Re: Response to October 19, 2016 Comments for EVOH Cover System Work Plan
North Quarry, Bridgeton Landfill, Bridgeton, Missouri Revision 2

EVOH Cover System Work Plan

North Quarry Bridgeton Landfill

ENGINEERING PLANS FOR THE EVOH COVER DESIGN AT BRIDGETON LANDFILL BRIDGETON, MISSOURI

SHEET NO.
1A
PROJECT NO.
160512

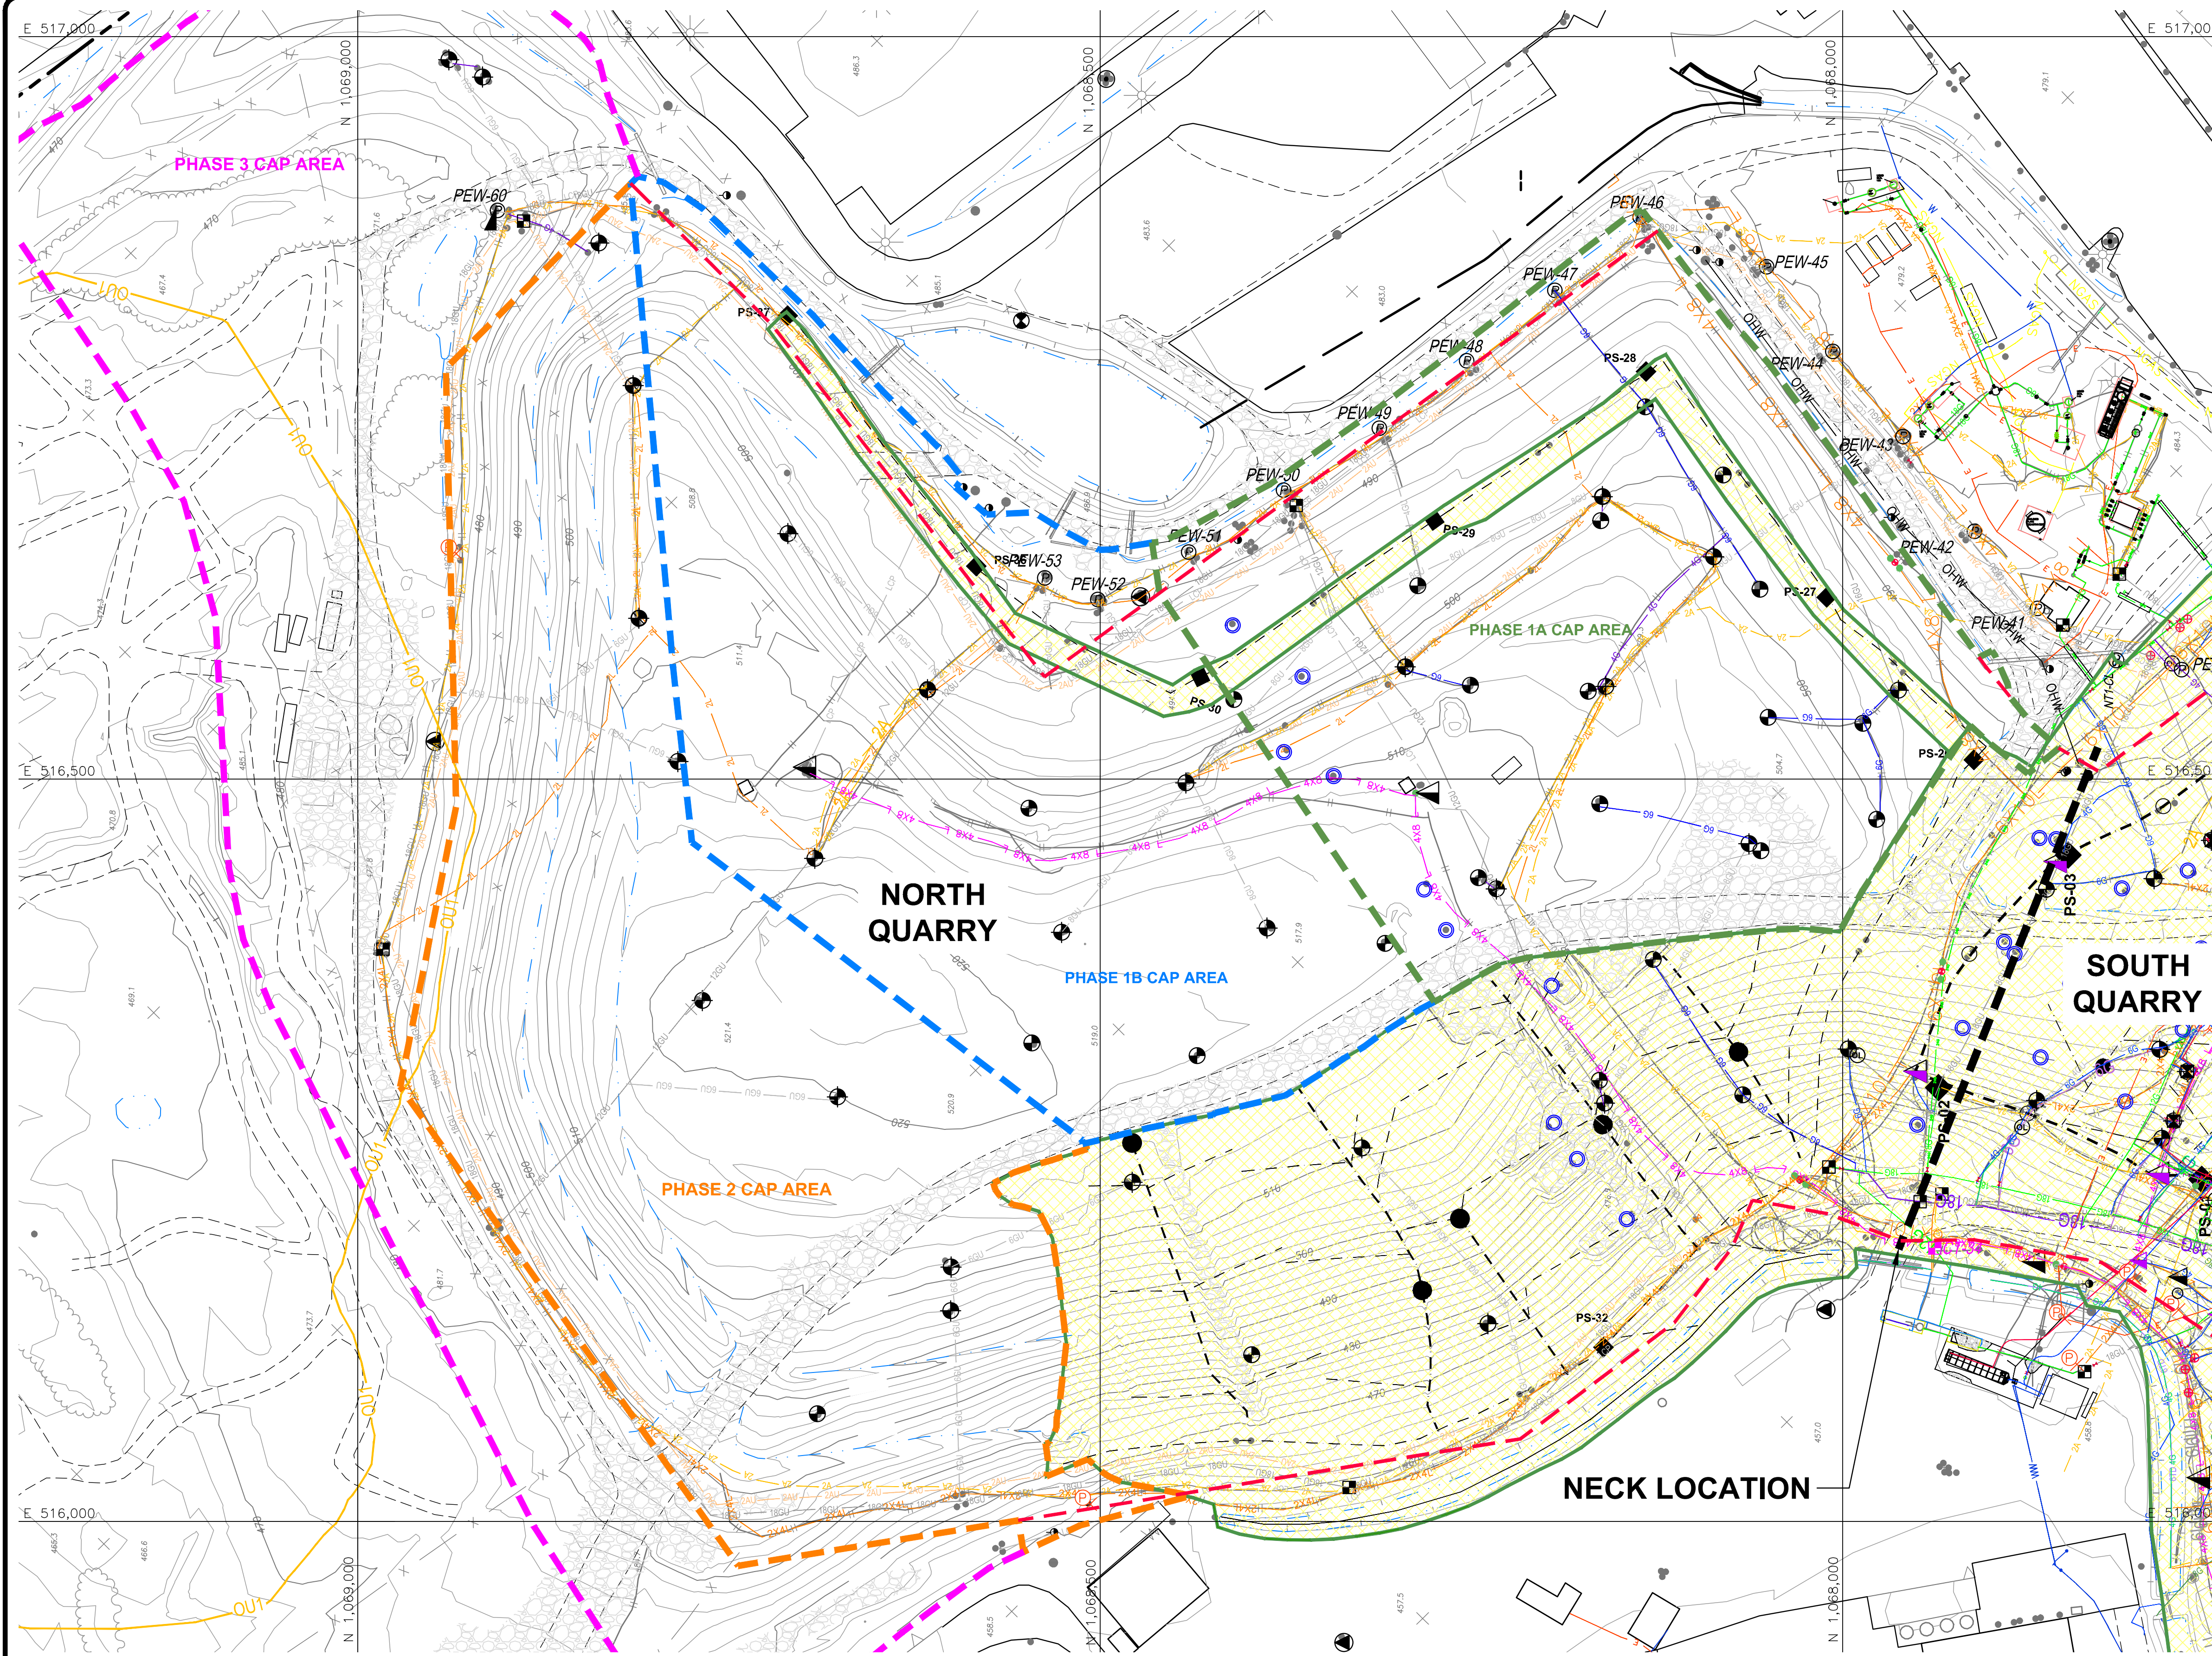
Comment #3: Section 2, middle of page, refers to a 14-sheet drawing set, while reviewers can only identify 12 plus 1A, for 13 drawings total. Please note this was listed as 11 drawings in the previous submittal. Please clarify correct number of drawings to 13 (or 14 if including the cover page/drawing index with the EVOH designs and cut sheets).

Response #3: *the plan set is a 14-sheet drawing set including the Title Sheet. The Title Sheet has been added to the list of drawings in Section 2.*

DETAIL 1/6
SCALE: NOT TO SCALE

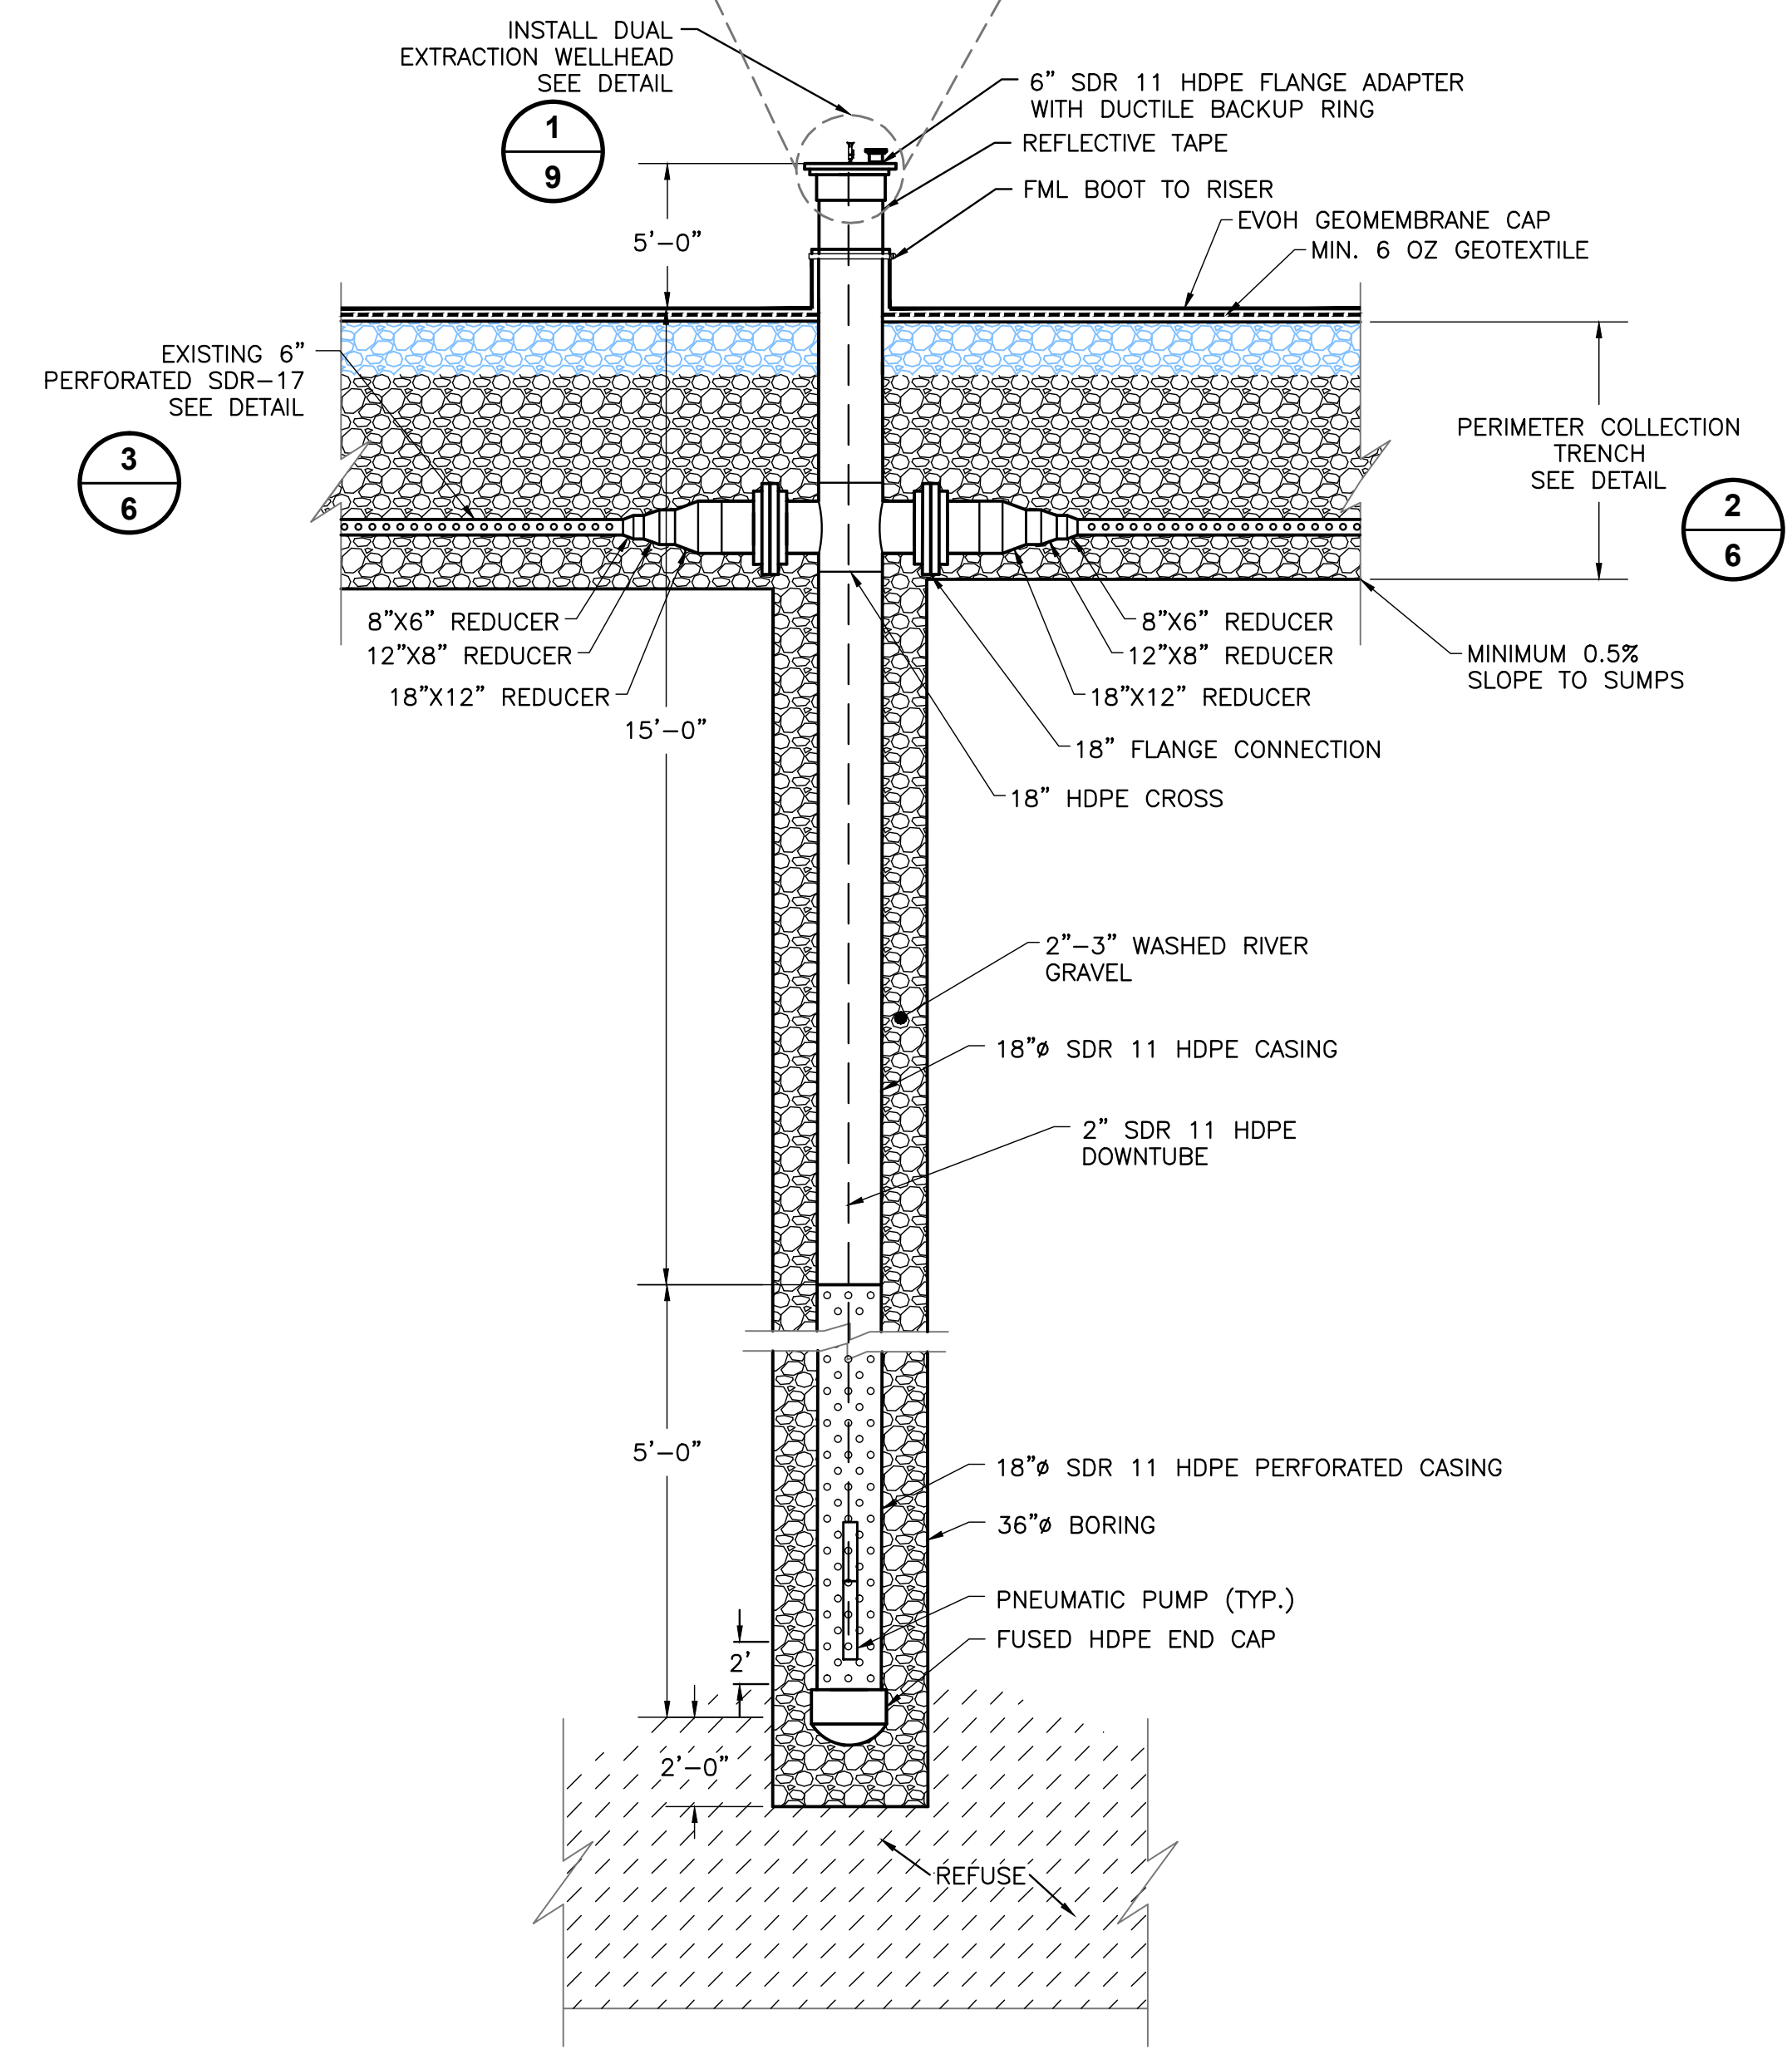
- a. The Detail reference does not appear to have been changed to Detail 1, sheet 6;
- b. "Are be" is to be changed to "have been";
- c. The work plan should provide details of how the work will be phased, including when the under and above cap features will be designed.

Response #1: *the requested change has been made to Section 3.32 on Page 1 of the revised EVOH Work Plan for comments 1a and 1b. A description of the phasing (from note 4 on Sheet 1 of the engineering plans) has been added as the second paragraph of Section 2 on page 2 to address comment 1c. The undercap and above cap features have been designed and are shown in the engineering plans for Phases 1A and 1B. Section 3.3 included the following statement to address the timing of design for Phases 2 and 3 undercap features. "The undercap features for the Phases 2 and 3 EVOH cover will be designed for those phases prior to construction of those phases based on future site conditions at that time." A similar statement for above cap features for Phase 2 and 3 has been added to Section 3.5 on page 8.*
